MINUTES OF MEETING
OF
THE 3rd MISSION OF THE PREPARATORY STUDY
FOR DEVELOPMENT OF SOUTHERN LARGE SCALE
THERMAL POWER PLANT IN IRAQ

AGREED UPON BETWEEN
MINISTRY OF ELECTRICITY OF IRAQ
AND
THE STUDY TEAM OF
JAPAN INTERNATIONAL COOPERATION AGENCY

AMMAN, 27TH-30TH NOVEMBER, 2011

Preliminary Study for
Development of Southern
Large Scale Thermal Power
Plant in IRAQ
Nasrlyah II
PROJECT
COMBINED CYCLE POWER
2 on 1 Multi Shaft Train
OVERALL SCHEMATIC
DIAGRAM

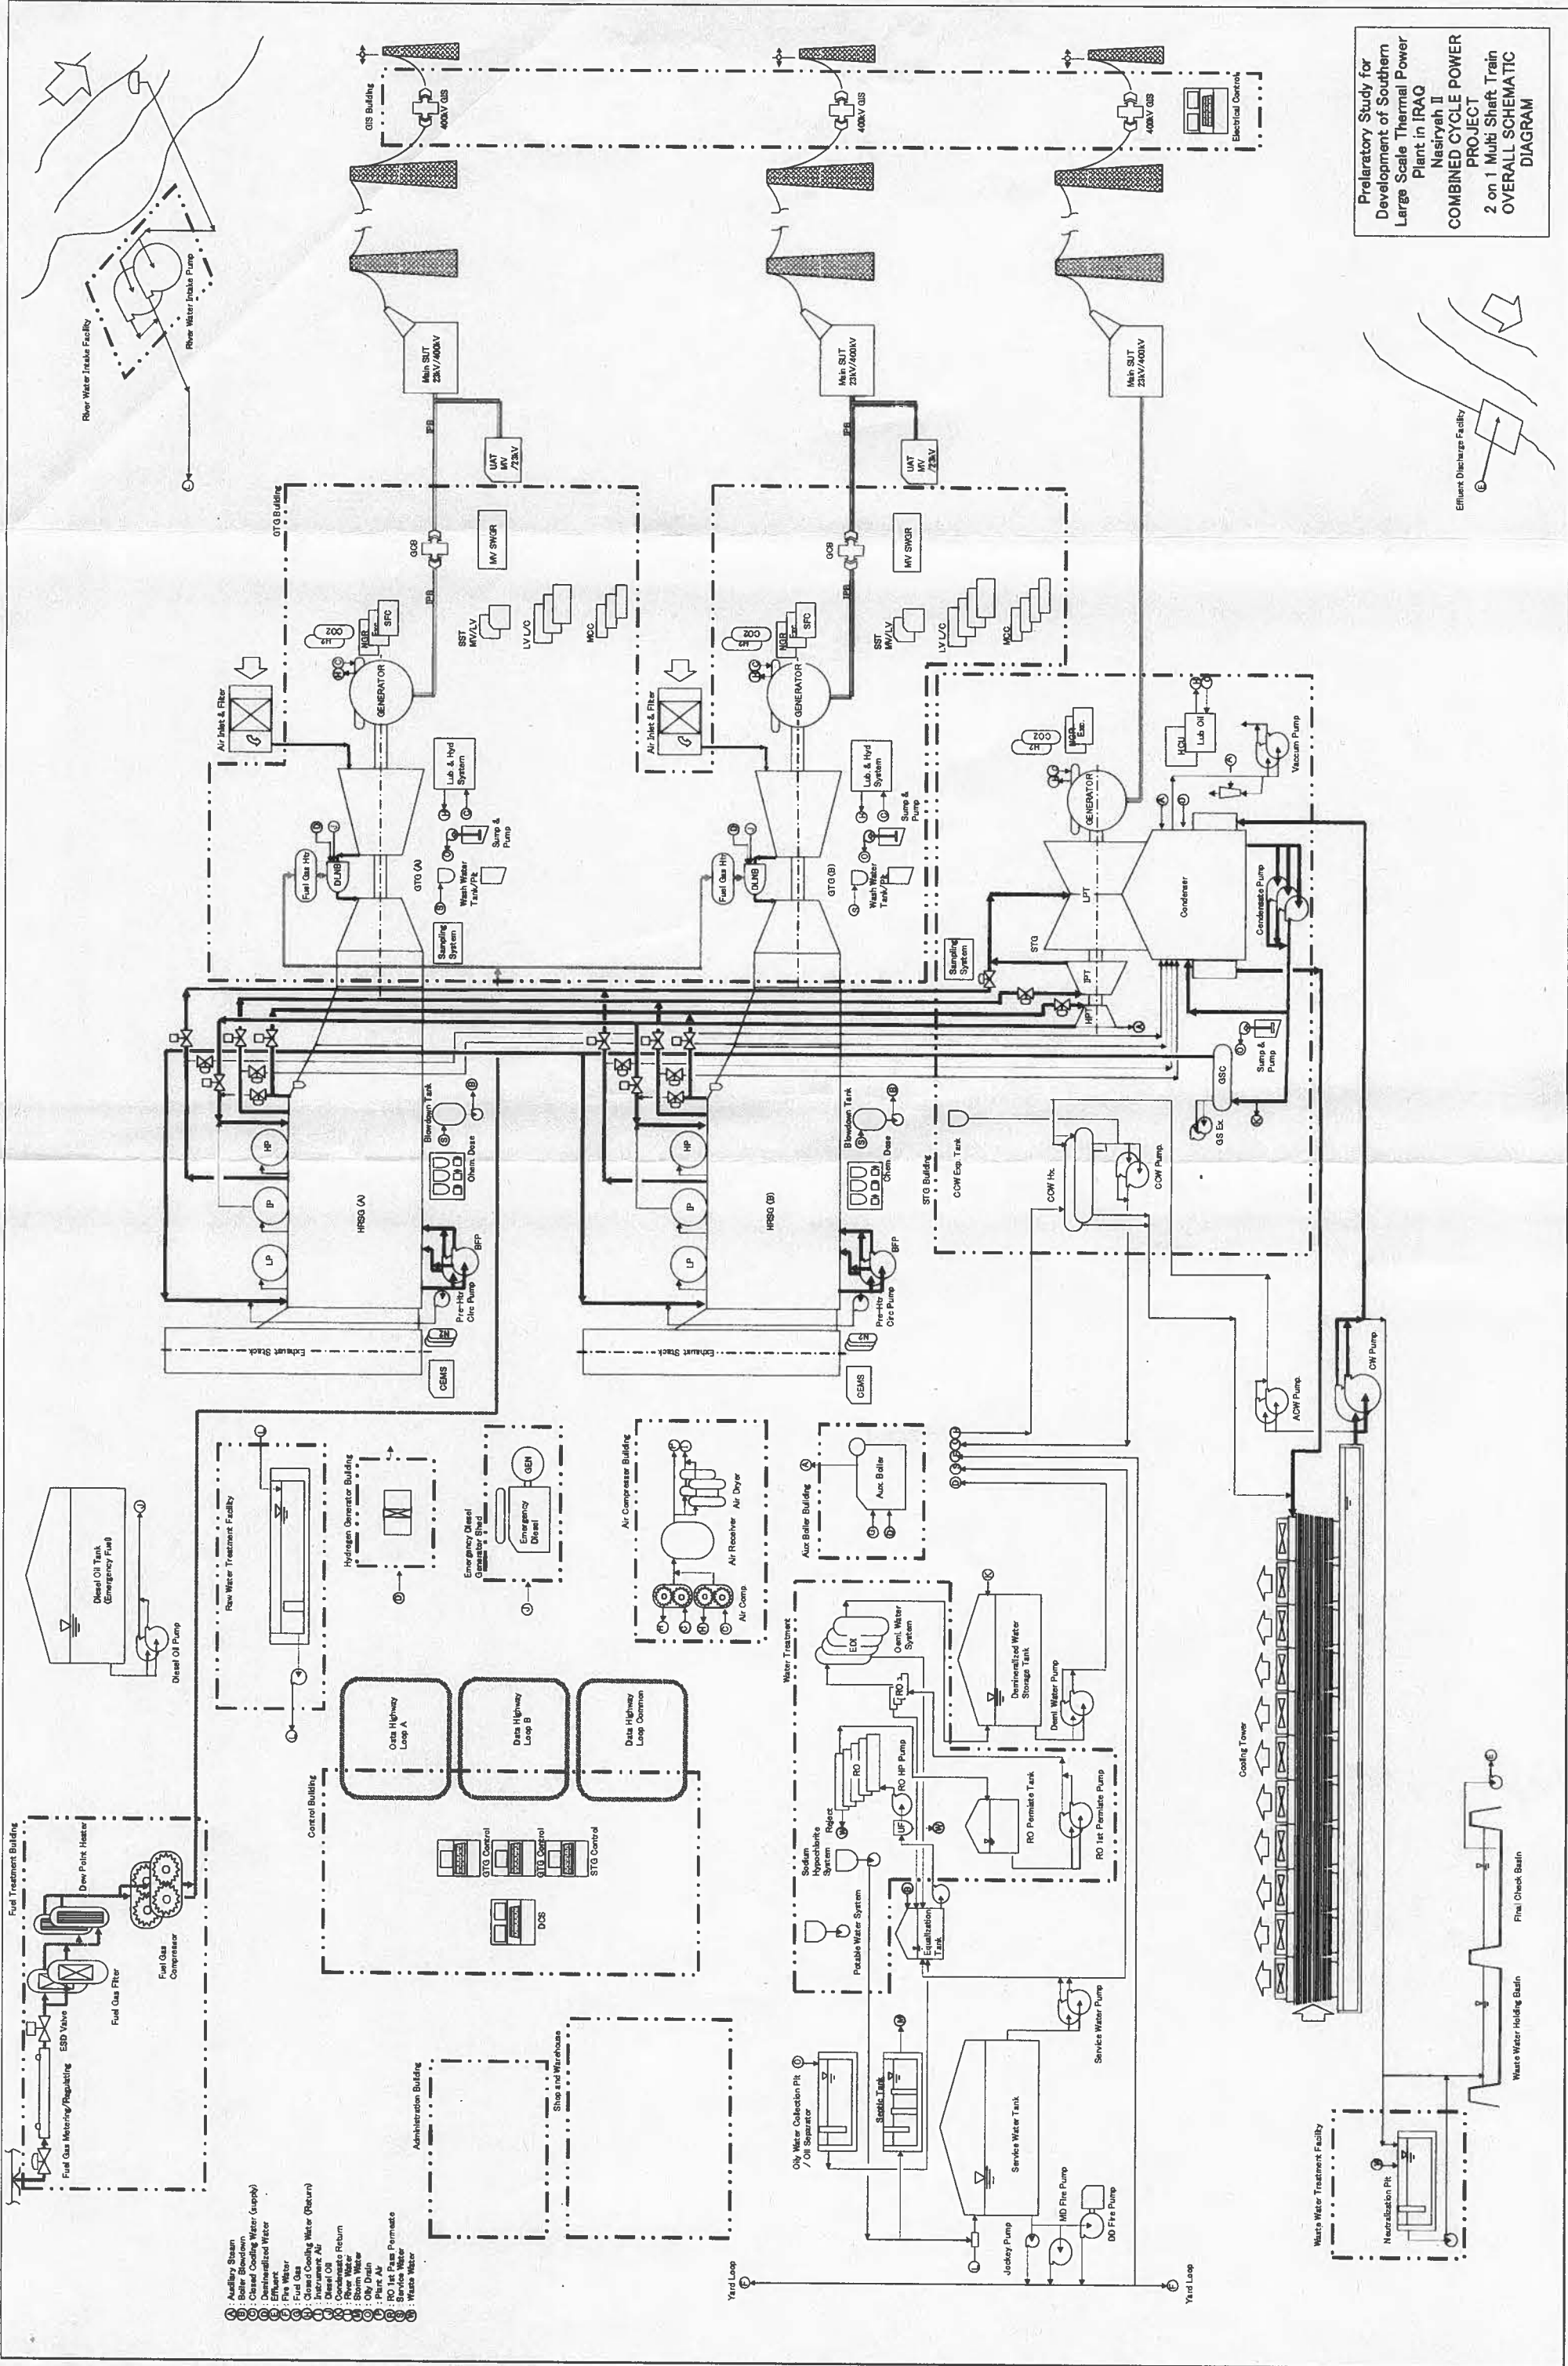
The configuration concept presented is basically agreed by MOE Team except for some comments shown below;

- Wet cooling towers with water pre-treatment is most probable method of the

steam turbine condenser cooling at this stage of the study though further investigation will be required taking into account the actual site conditions.

- Bypass stacks and dampers between Gas Turbines and Heat Recovery Steam Generators for simple cycle operation of Gas Turbine Generators are required.
- Fire Fighting Facility to include the foam system for the Diesel Oil Tanks.
- MOE Team requests the diesel driven fire water pump which will directly intake the water from river with adequate filtration.
- MOE Team requests the Hydrogen Generation Plant and Nitrogen Generation Plant based on local condition of gas procurement.
- Water related systems need to be evaluated carefully with the actual site conditions.
- MOE Team requests JICA Study Team to take into account the local weather conditions such as frequent dust and sand storms in facility design.

Preparatory Study for Development of
Southern Large Scale Thermal Power Plant
in IRAQ
Gas Combined Cycle Power Plant
2 on 1 Multi-Shift
Conceptual Plot Plan

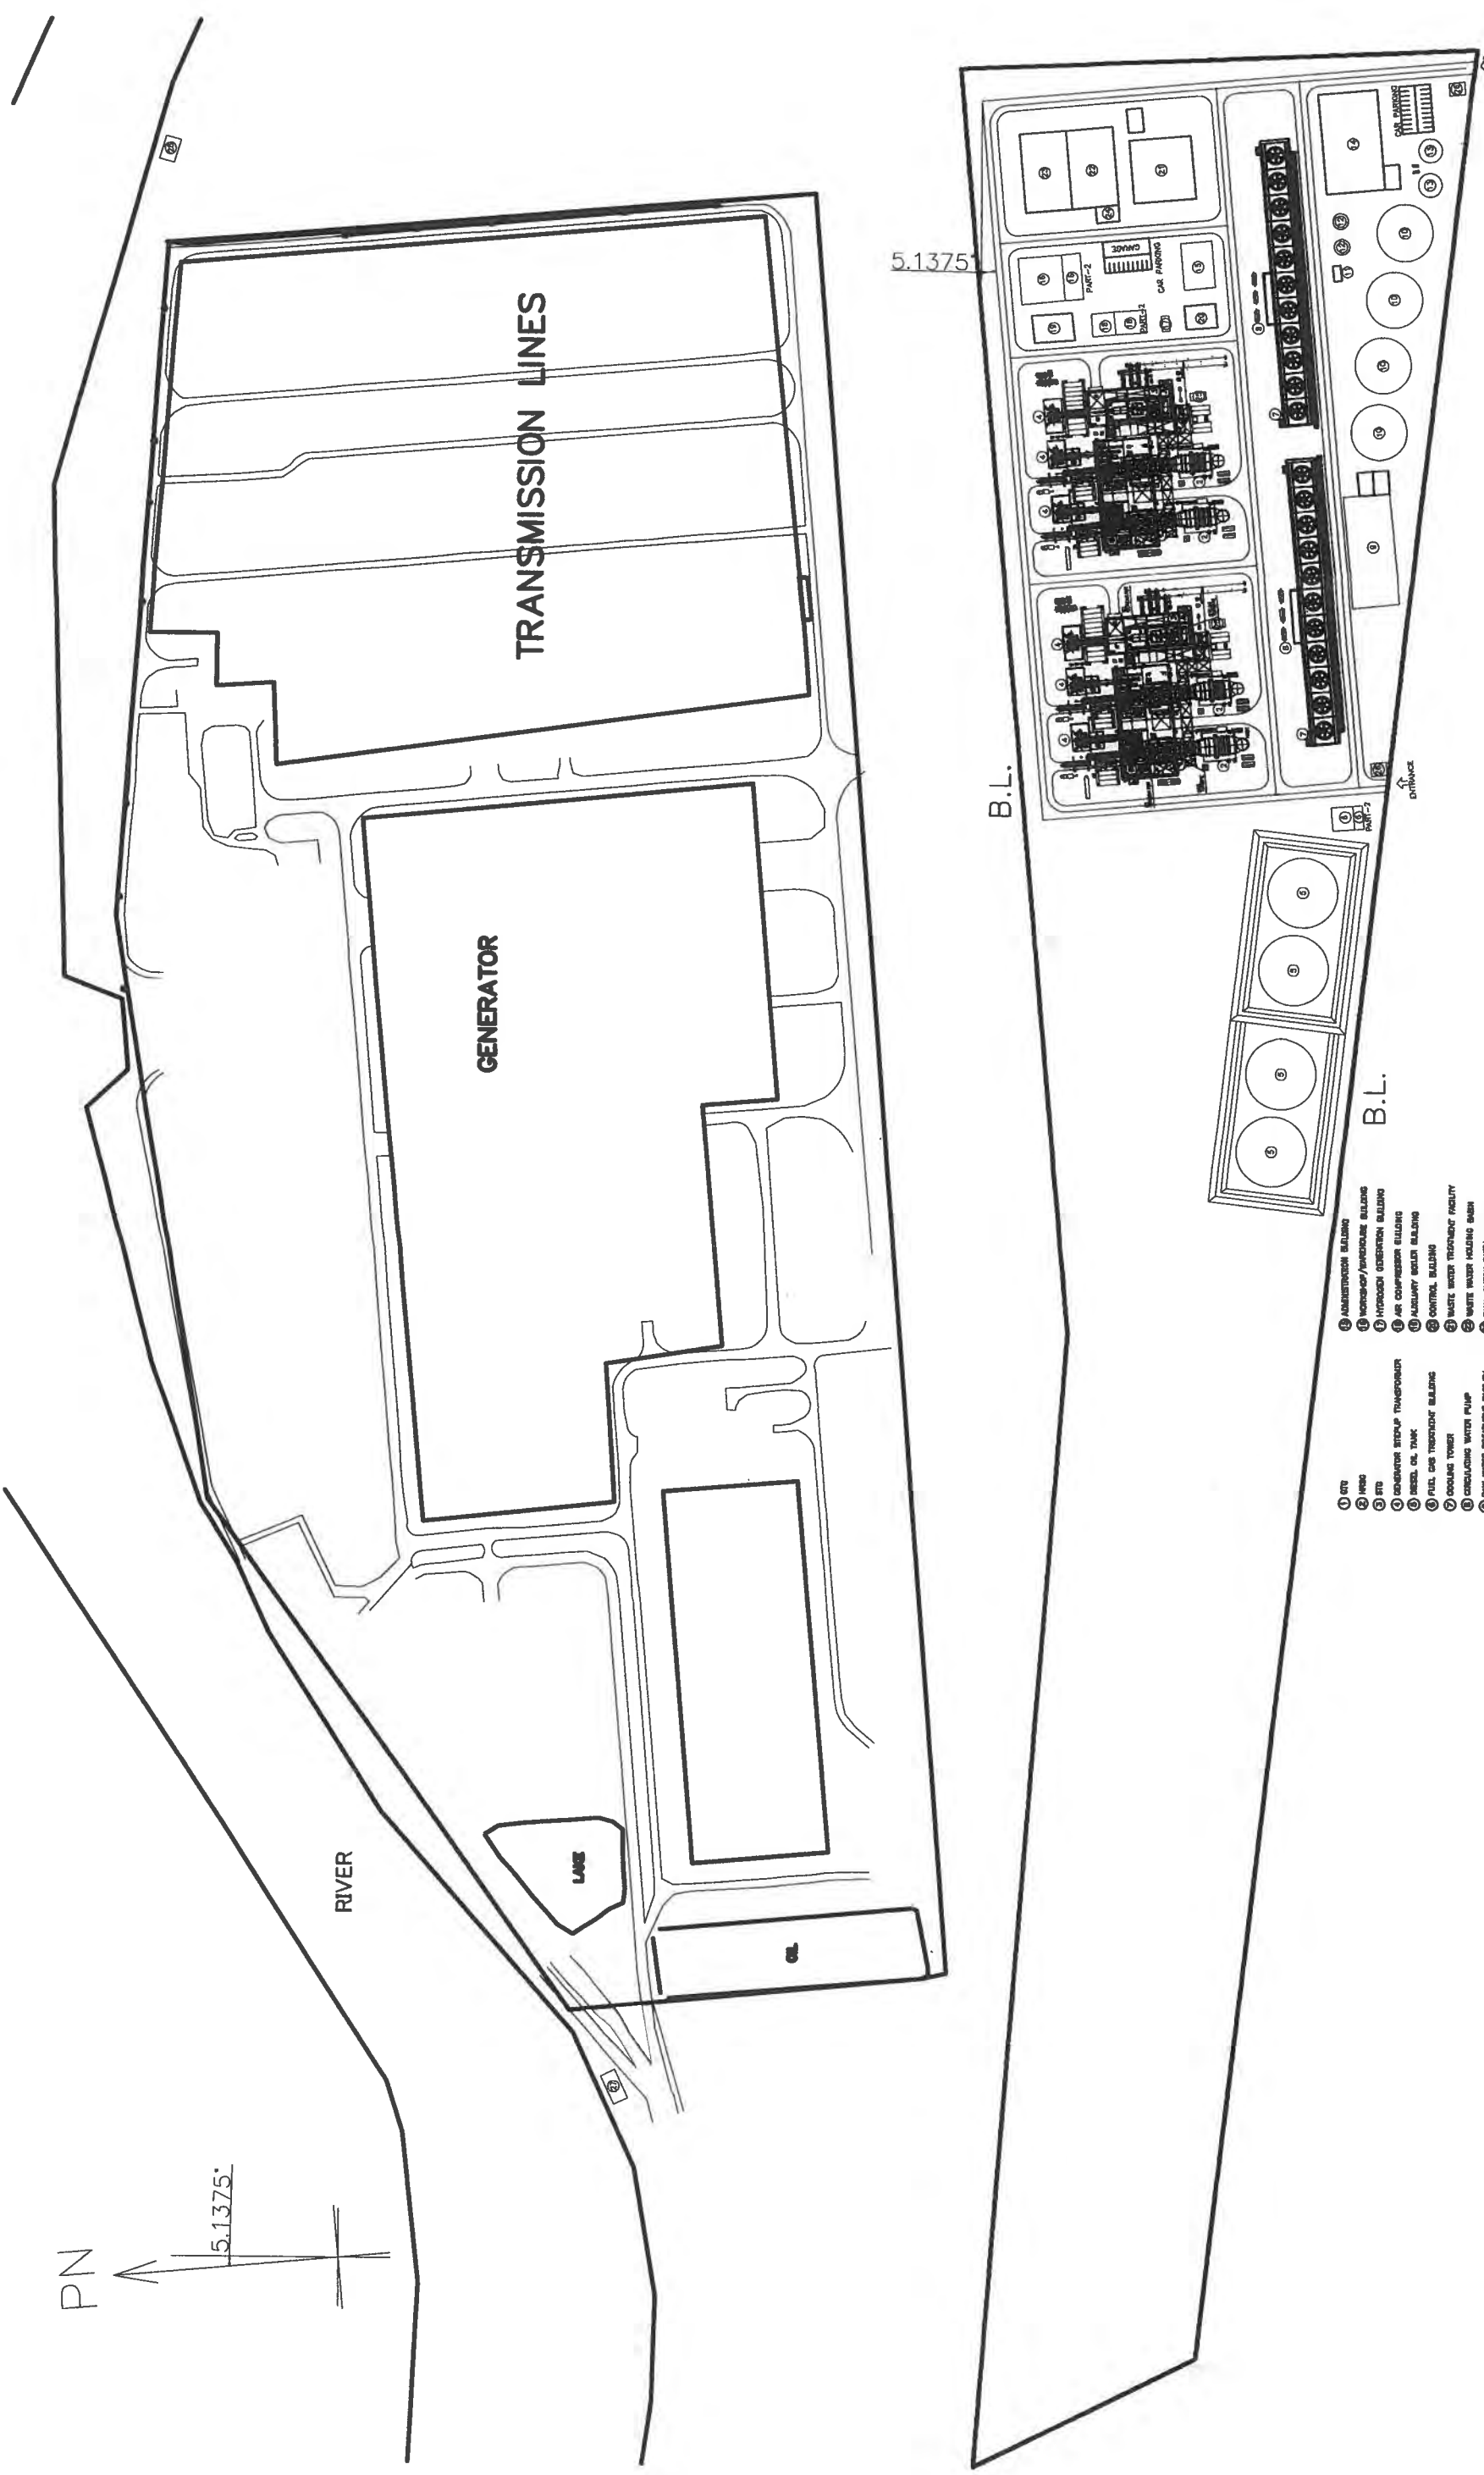
The plot plan presented is basically agreed by MOE Team except for some comments shown below;

- Bypass stacks and dampers between Gas Turbines and Heat Recovery Steam Generators for simple cycle operation of Gas Turbine Generators are required.
- Interface with the fuel gas pipeline to be indicated
- River water makeup pipeline to be indicated
- Area for 400kV connection between Generator Step Up Transformers and GIS facilities to be indicated.
